Certificate of Appropriateness

1945 N. BARTLETT AV.

Firehouse No. 5

PTS ID 114357 COA: rehab for residential use

4 SOUTH ELEVATION
SCALE: 1/4" = 1'-0"

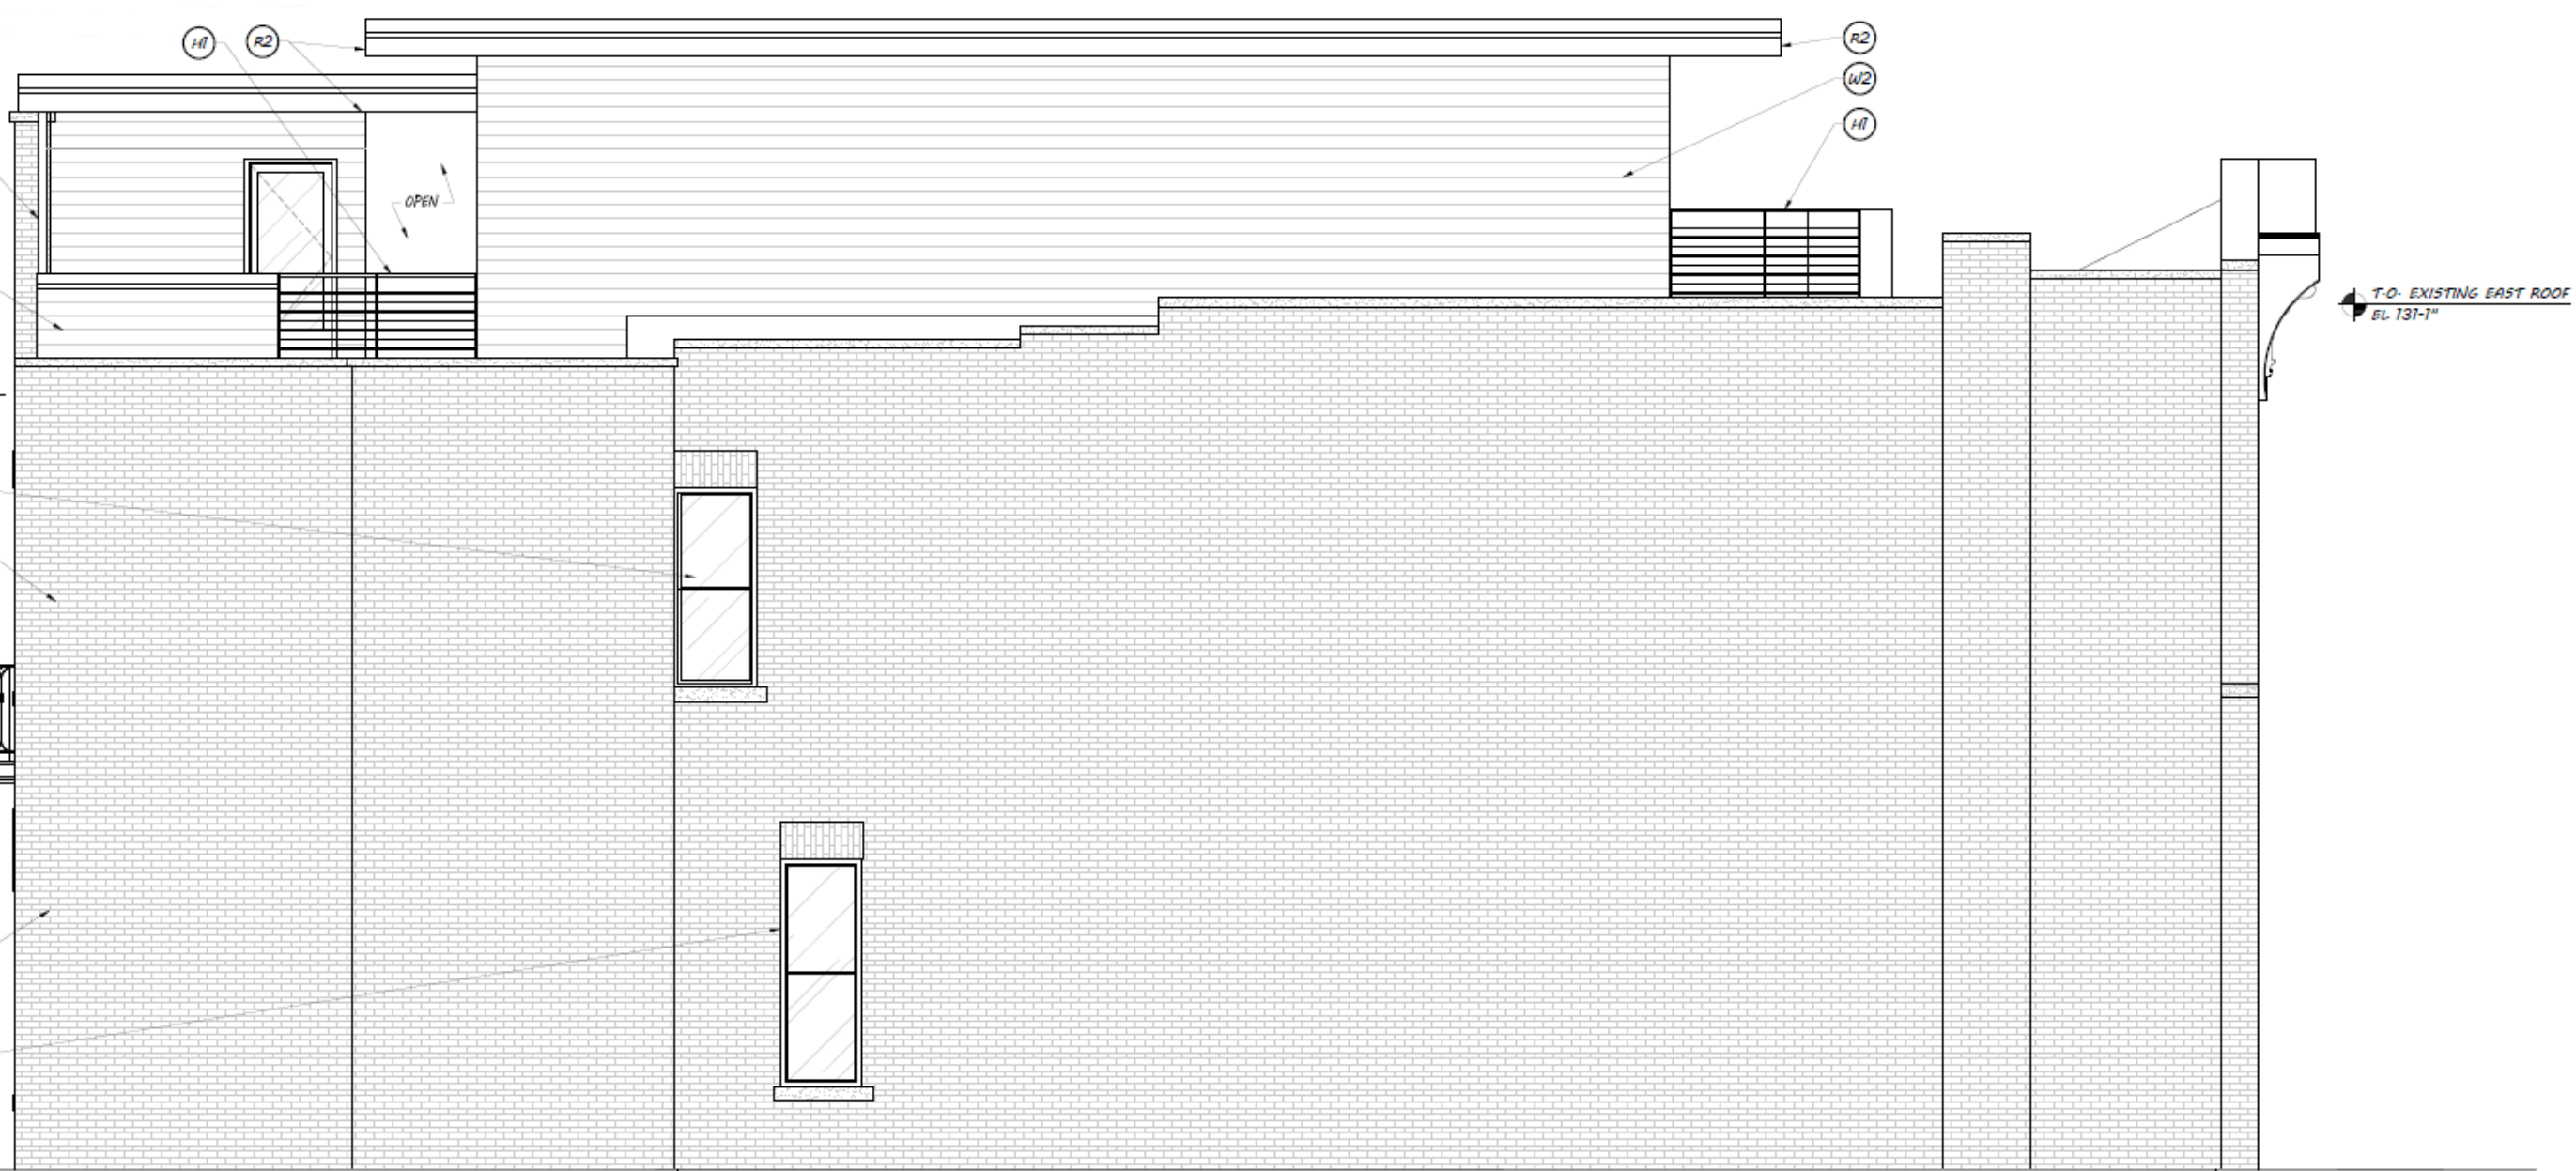
NEW WINDOW TO MATCH EXISTING
IN NEW MASONRY OPENING

2 **NORTH ELEVATION**
SCALE: 1/4" = 1'-0"

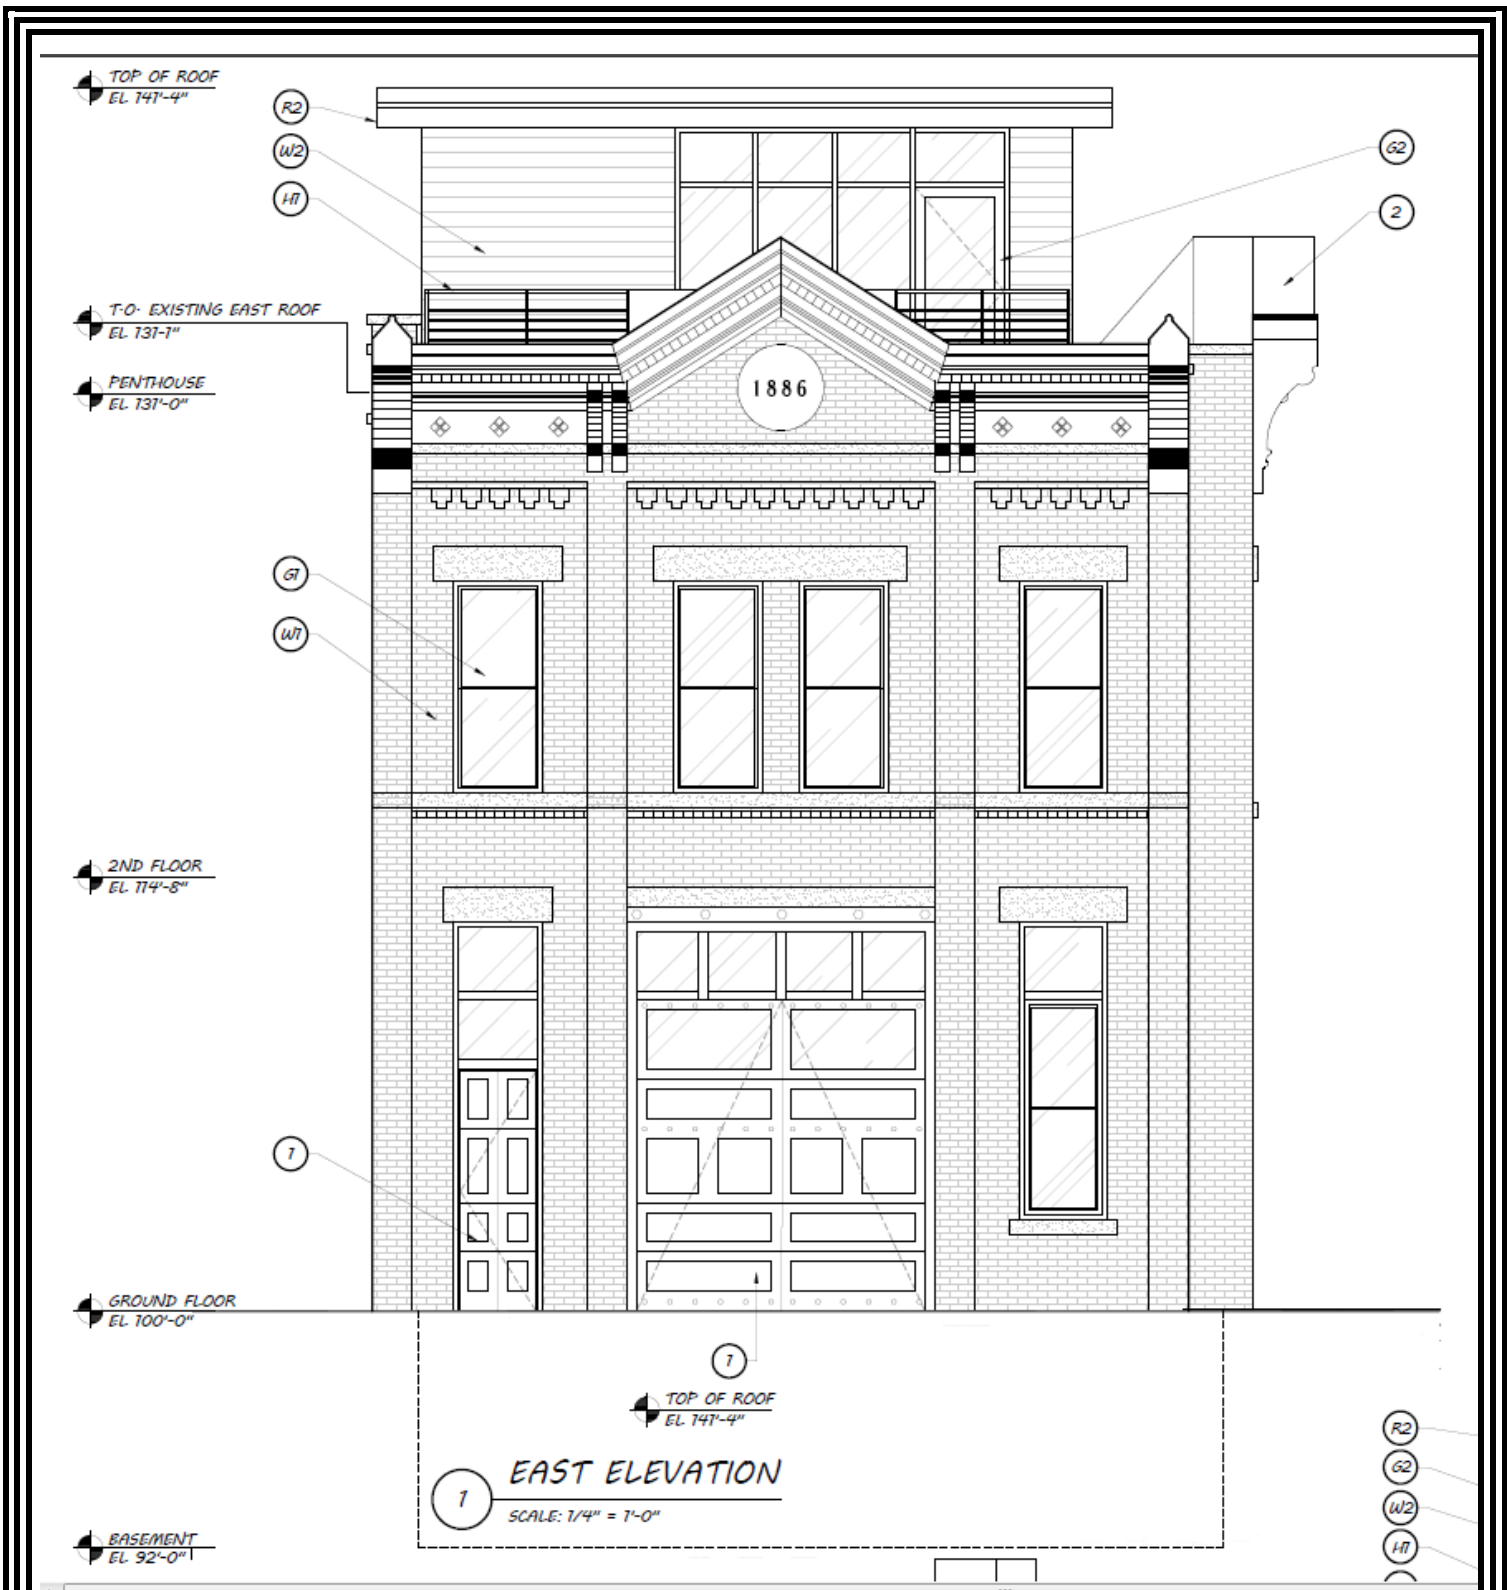
Lettering on east gablet medallion is to be corrected to "Ladder Co. N^o 5" or "No. 5" or be blank. Door at balcony is NOT APPROVED AS SHOWN

Final shop drawings for ground floor doors must be approved separately.

Third floor doors and windows are approved as shown.
New doors and windows in original structure are not approved at this time and are subject to further review.

Rough openings and second floor balcony may proceed.

Hayloft door on north elevation.

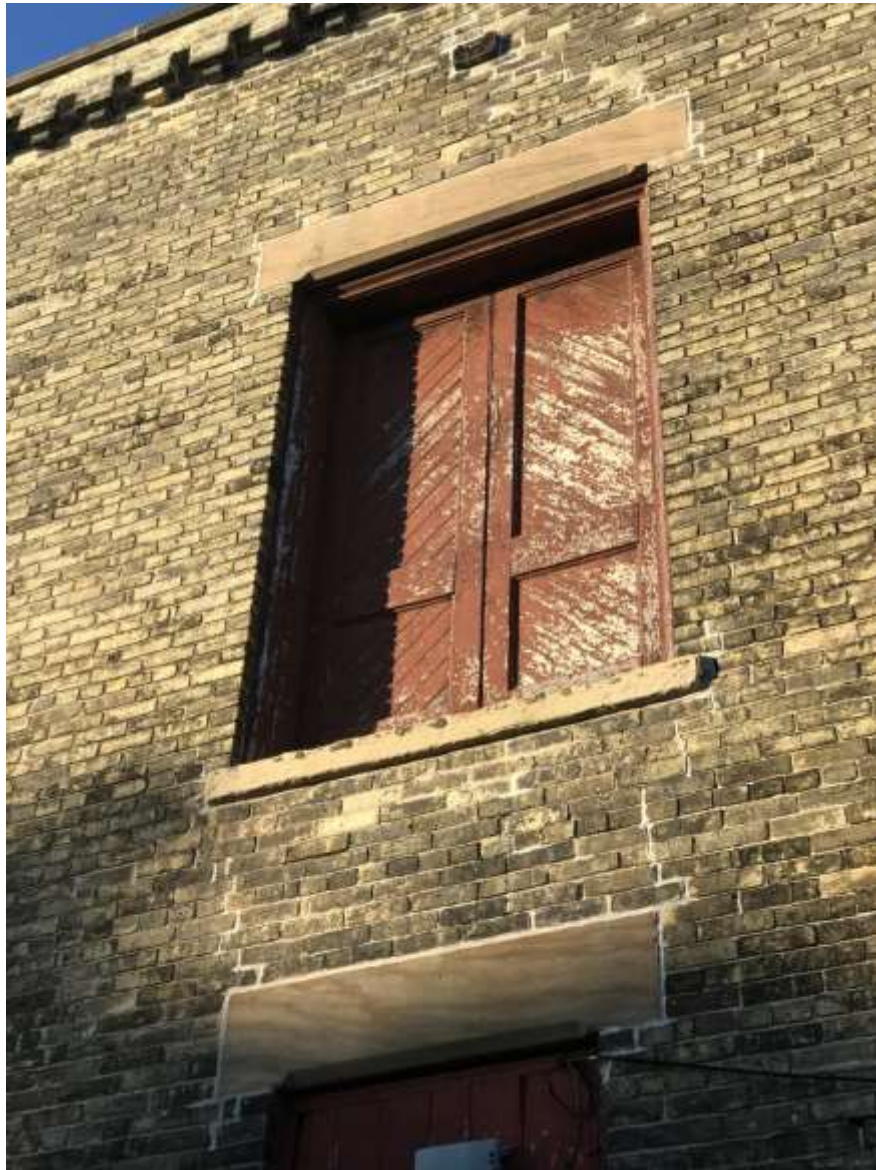
1. Eliminate varnished wood from rear elevation and use paint/opaque stain on wood.
2. Complete masonry cleaning as approved by HPC staff at on site meeting with Beyer Construction.
3. Retain and repair existing hayloft doors. Obtain a bid for repair from a qualified carpenter for repair before pursuing replacement.
Replacement of this door must be approved separately
4. Submit shop drawings for all new windows, doors, and railings. All windows and doors shall be all wood and railings on the first two floors shall be metal with a painted or powder-coated finish.
5. Submit landscape plan for review by staff, if it involves any retaining walls, structures, or plants exceed 18" at mature height.
6. Formal mortar testing is required
7. Test panels of mortar for tuckpointing and their chemical composition must be reviewed by staff before construction begins.
